# Access Compliance Report

## Public Rights-of-Way

Intersection ID: 42932	Main Street: CARNSORE_CT	Cross Street: HOLLY_PARK_DR	Location: S
ADA ID: F556F19852F8	Ramp Type: PerpDiag	Initial Pass/Fail: Fail	Overall Compliance: No
Codes/Mitigation Info/Possible Solution		Field Measurements/Component Compliance	
Severity Score: 46.25

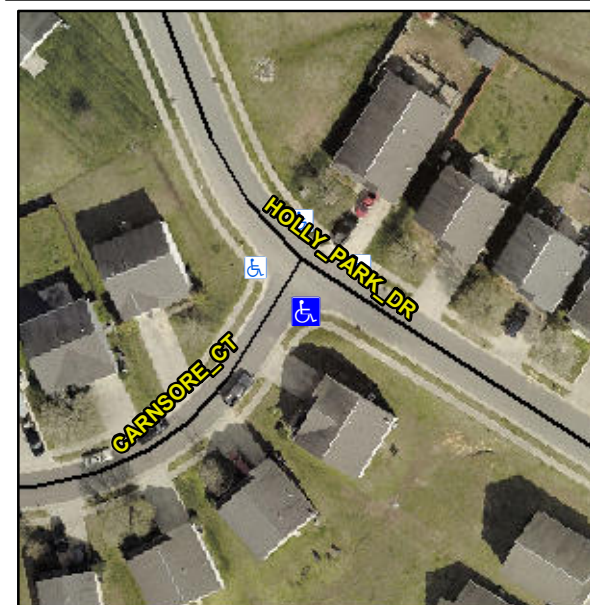
**Not Found, R304.5.1, R304.2.2, R304.5.3**

Compliance	Description	Data	Compliance	Description	Data
N/A	Ramp Length (in)	48.0	No	Ramp Slope (%)	10.1
No	Ramp Width (in)	40.0	No	Ramp XSlope (%)	10.3
N/A	Flare Type LT	N/A	N/A	Flare Type RT	N/A
N/A	Flare Slope LT (%)	N/A	N/A	Flare Slope RT (%)	N/A
N/A	Flare Traversable LT?	N/A	N/A	Flare Traversable RT?	N/A
N/A	Landing Length (in)	N/A	N/A	DWS Provided?	N/A
N/A	Landing Width (in)	N/A	N/A	DWS Contrast?	N/A
N/A	Landing Slope (%)	N/A	N/A	DWS Length (in)	N/A
N/A	Landing X Slope (%)	N/A	N/A	DWS Full Width?	N/A
N/A	Landing Curb? (Y/N)	N/A	N/A	DWS Offset (in)	N/A
N/A	Shared Landing?	N/A			
N/A	Gutter Ponding?	N/A	N/A	Gutter Slope (%)	N/A
N/A	Gutter Lip Ht (in)	N/A	N/A	Gutter X Slope (%)	N/A
N/A	Painted X Walk1?	No	N/A	Painted X Walk2?	No
	X Walk 1 Direction	To NE		X Walk 2 Direction	To NW
N/A	X Walk 1 Width (in)	N/A	N/A	X Walk 2 Width (in)	N/A
	X Walk 1 Slope (%)	4.4		X Walk 2 Slope (%)	3.3
	X Walk 1 X Slope (%)	5.2		X Walk 2 X Slope (%)	6.7

**Remove & Replace Curb Ramp With Two New Directional Ramps or Equivalent.**
